HUEBNER SQUARE TOWNHOMES, P.U.D. MASTER DEVELOPMENT PLAN

APPLE DEVELOPMENT, L.P.
 HUEBNER SQUARE TOWNHOMES, P.U.D.
 MASTER DEVELOPMENT PLAN

Re: **Huebner Square Townhomes**

MDP # 006-06

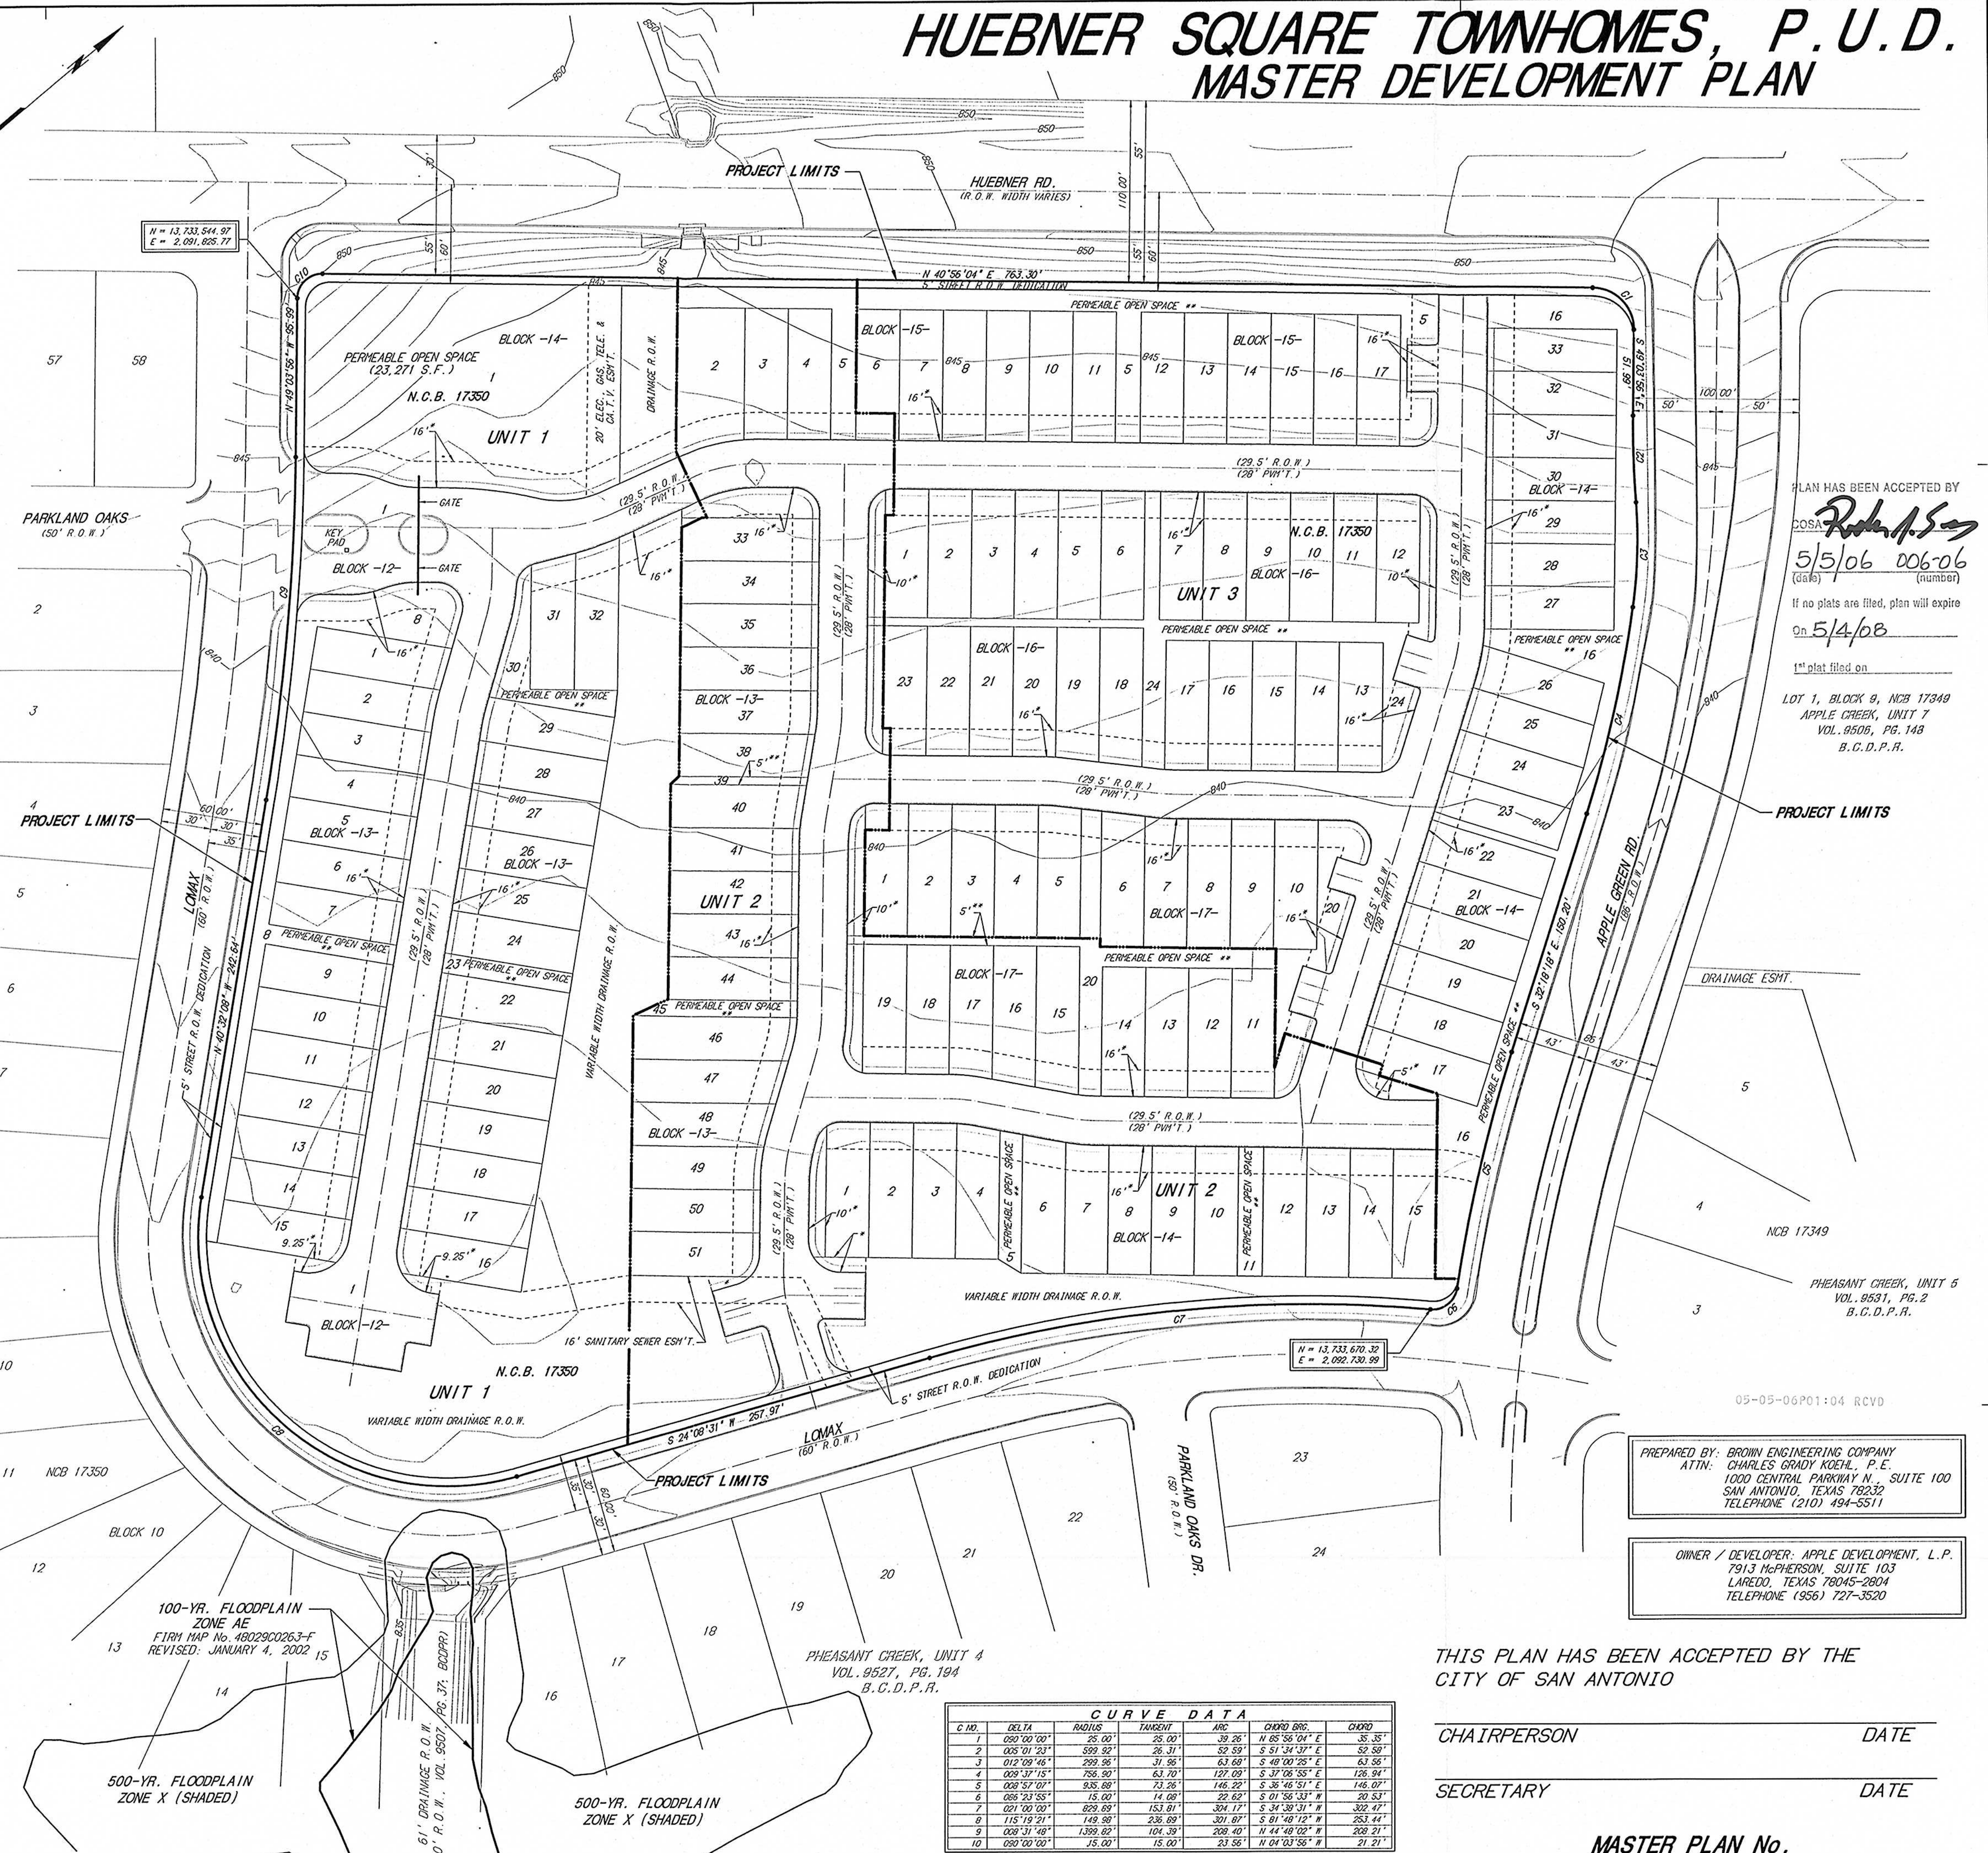
- In consideration of public safety and convenience, excessive grades by reason of topography should be avoided in street layouts and arrangements.
- Any access and R.O.W. issues along state facilities will need to be resolved with the **Texas Department of Transportation (TXDOT)**. For information about these requirements you can contact TXDOT at 615-5814.

- This development will need to comply with **Tree Preservation** ordinance #85262. For information about these requirements you can contact Building Inspections at 207-7102.

- It will be expected that you will plat all of the property depicted in your Master Development Plan (M.D.P.) to include floodplains, drainage areas and open space.

- I would encourage you to work closely with the school district, so that they can plan accordingly.
- **Parks and Recreation:** Huebner Square Townhomes is a proposed subdivision with 133 multi-family residential units. UDC Section 35-503, Table 503-1 states that single-family development is required to provide 1 acre of park/open space per every 114 dwelling units. The requirement for this development is 1.2 acres. This development provides 0.5 acres of park to include an Open Play Area for 1.0 acre credit and a Picnic Area for 0.25 acres credit.

- The parkland provided is dedicated to the Home Owners Association.
- A Provision and Maintenance Plan is provided to this department at the time of platting.
- Parkland dedication must be platted by the second phase of development.
- Amenities provided follow design criteria set forth in Table 503-4 in order to gain parkland credit.

- All access roadways shall provide clear sight distance on all existing and proposed roadways in order to provide adequate obstruction free viewing distances for approaching traffic. All signage, landscaping, and improvements shall be selected and located so as to not block these clear sight distance areas.
- All commercial driveways for this project shall comply with UDC 35-506, (r) Access and Driveways.
- Sidewalks along all interior and exterior roadways are to be installed in accordance with UDC 35-506(q).
- Hammerhead turnaround at the end of streets will be required to meet the International Fire Code or the City of San Antonio requirements for fire truck turnaround.
- Please be aware that by UDC requirements there is no on-street parking allowed on 27-foot wide roads.
